**Subject:** Submission - D/2024/179 - 87 Lower Fort Street MILLERS POINT NSW 2000 - Attention Marie Burge

# Easton Planning Consultants

This letter outlines objections pertaining to proposed building envelope at 87 Lower Fort Street, Millers Point (D/2024/179).

Figure 2 Deposited Plan (source: Infin Architects)

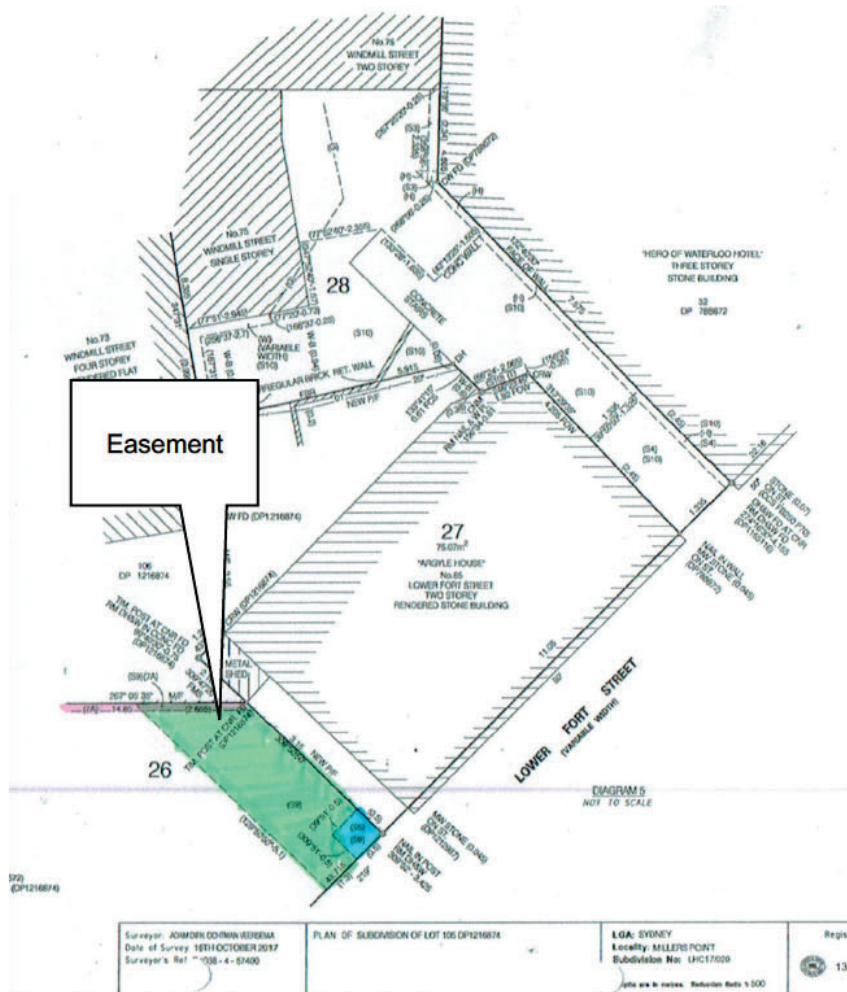
The architectural plans submitted under D/2024/179 note a 1.8 metre easement exists on boundary which borders our client’s property (Argyle House).

Presently, there is a fence on the boundary between our client’s property and the subject site. Our client has access to the easement area which houses their services.

Development application D/2024/179 lacks in evaluating impacts on our client's easement and their asset. We seek the Council obtain information on the following:

- Will existing fence with 85 Lower Fort Street be retained or replaced?
- What fence will be present on the Lower Fort Street front boundary to shield our clients' assets?
- What landscaping measures will occur to keep the easement area accessible by our client?

We seek that Council require the applicant to address how the easement will be protected from public while allowing access from our client's property. In our opinion, a replacement fence and a landscape maintenance schedule would ensure the easement area is accessible by private owners and is not neglected in the future.

Figure 9 Proposed ground floor plan (source D/2023/1036)

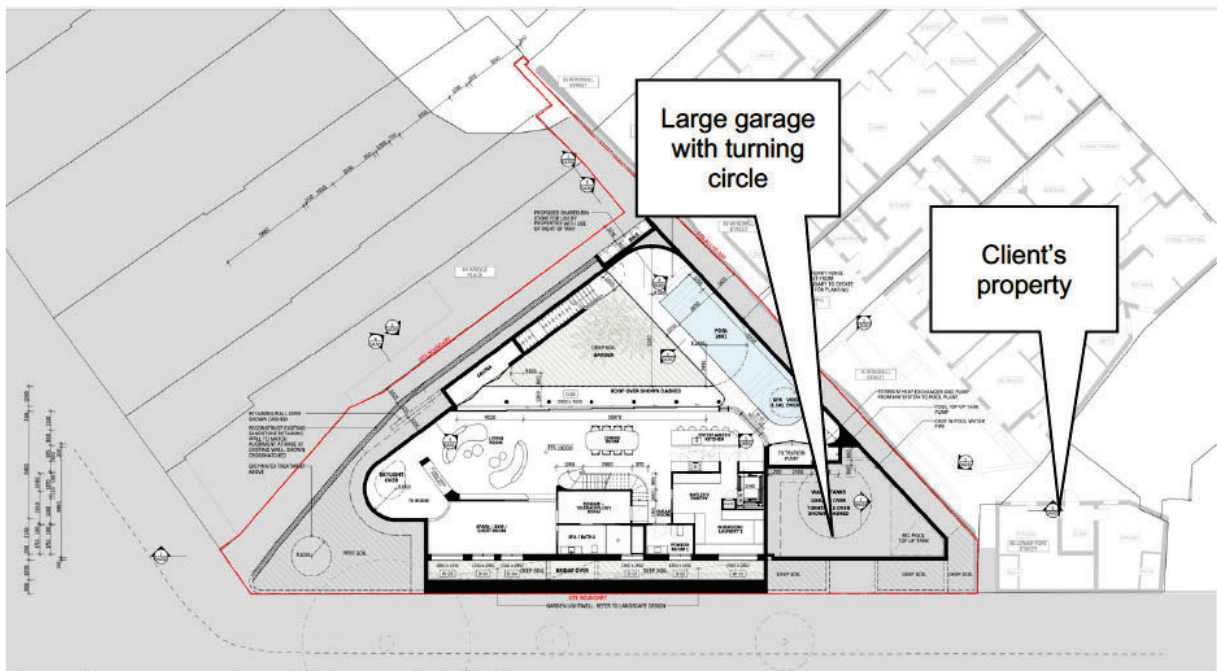
The proposed development under D/2023/1036) exhibits a design which is deemed an overdevelopment on site. The proposed two attic spaces with adjoining roof terrace and not wholly contained within the roof space. Therefore, the proposed attic design creates the appearance of a third storey on site.

Additionally, the proposed plans show a large garage with turning table and plant room located near our client's side boundary. There will be acoustic impacts on our client's property due to this design choice.

Brick buttress and retaining wall

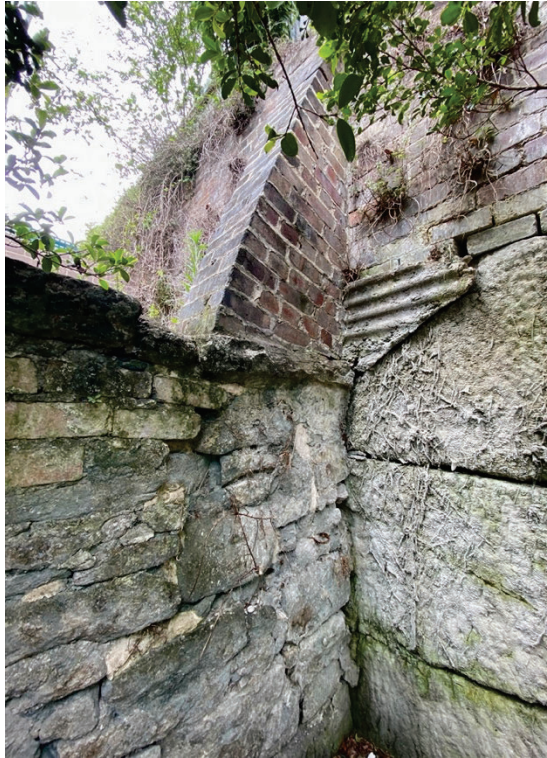
Despite some evidence of cracking and the failed buttress, the sandstone rubble wall and brick infill wall appear to be stable and capable of supporting the existing load. In accordance with the recommendations of the CMP and associated engineering advice and subsequent engineering advice, we have been continually monitoring the wall in 67 Windmill Street and removed the vegetation recommended in the CMP.

The proposed development will increase the loadings onto the retaining walls and as noted in the geotechnical report there is significant potential for ground vibration to these walls and adjoining properties. Refer extract below.

### Sketch Image 1-Southern Boundary to Lower Fort Street

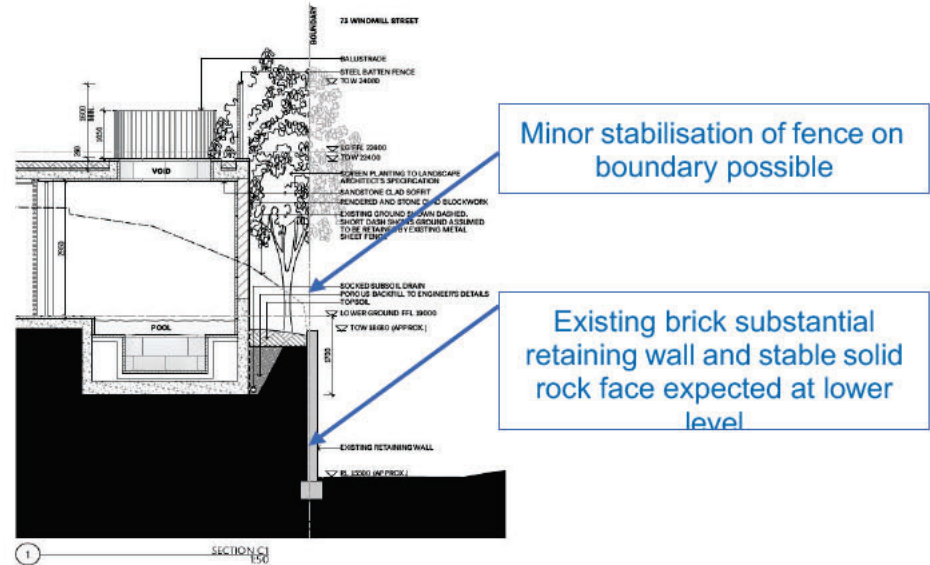
The structural report review does not consider the full length of the retaining wall at 67 and 69 Windmill Street and how the retaining walls will be impacted by the development. The report addresses 73 Windmill Street only as shown on the image below. The heritage retaining wall is not a substantial brick wall in the other properties as outlined above and there is no detail in how the retaining walls are satisfactory for the proposed development. The information shown is incorrect. The existing retaining wall is shown incorrectly and does not represent what is on site.

The architectural drawings show a section of the retaining wall of 69 Windmill Street, however this is also based on incorrect information on the wall.

There has not been any considered investigation in regard to the removal and excavation for the proposal nor the load from the proposed redevelopment including the landscape treatment on the entire retaining wall that adjoins the boundary. We note the landscape treatment is to provide better amenity to the adjoining landowners (which we discuss further below). However, there has not been a considered investigation in regard to whether the retaining walls, that is part of the CMPs for all properties, will be impacted by the landscape proposed. Neither the structural review nor geotechnical report discuss the potential impacts of the landscape treatment.

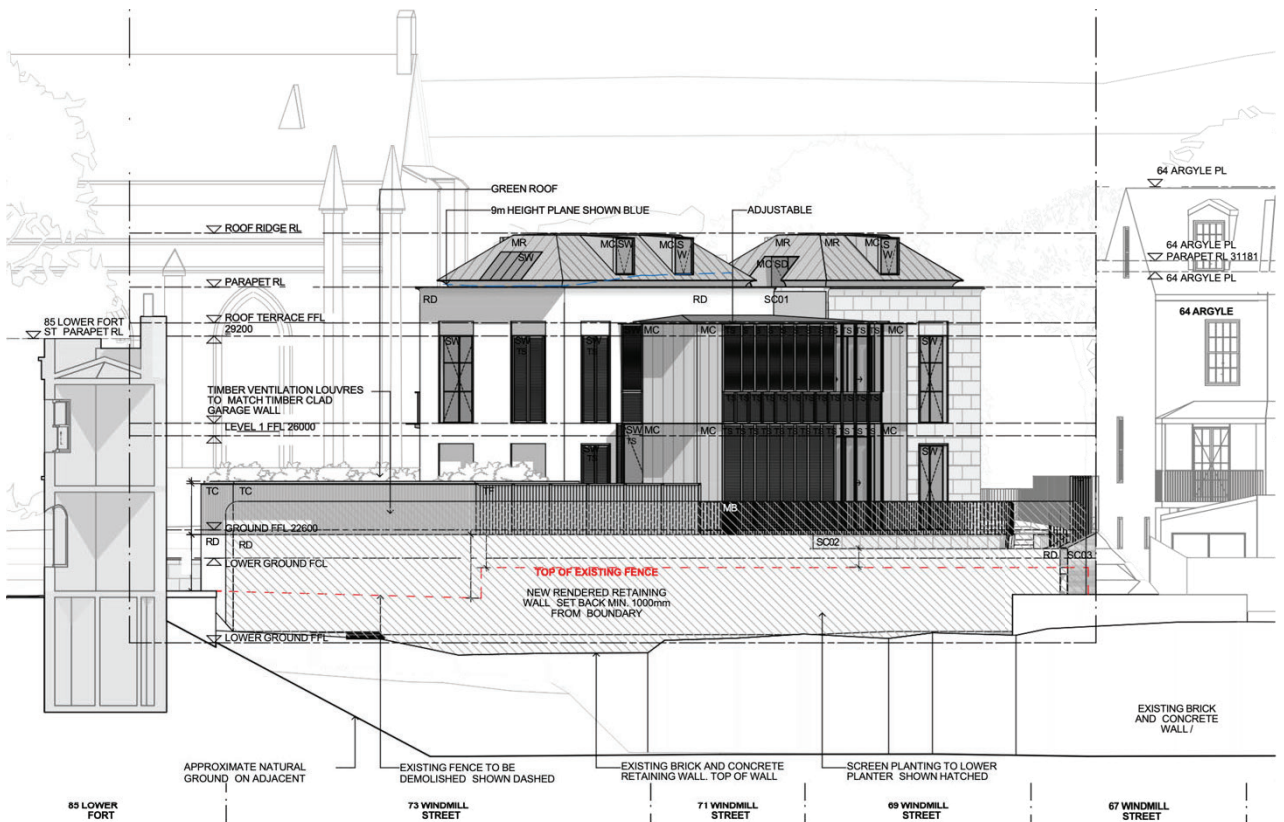
Due to the orientation of the building and the location and size of the windows and glass doors, views will be available directly to our living area and kitchen from the proposed ground floor living areas, outdoor courtyard, the first floor and roof top terrace at 87 Lower Fort Street.

The proposed development does not meet the requirements of the DCP as it has sill heights lower than 1.4m, all windows are opening and to full widths, glass doors are also proposed to open to full width and the building is orientated, which will look directly into our dwelling and we will look directly into the proposed dwelling. Whilst there are screening devices, these are fully adjustable and do not provide any visual privacy for the occupants or us.
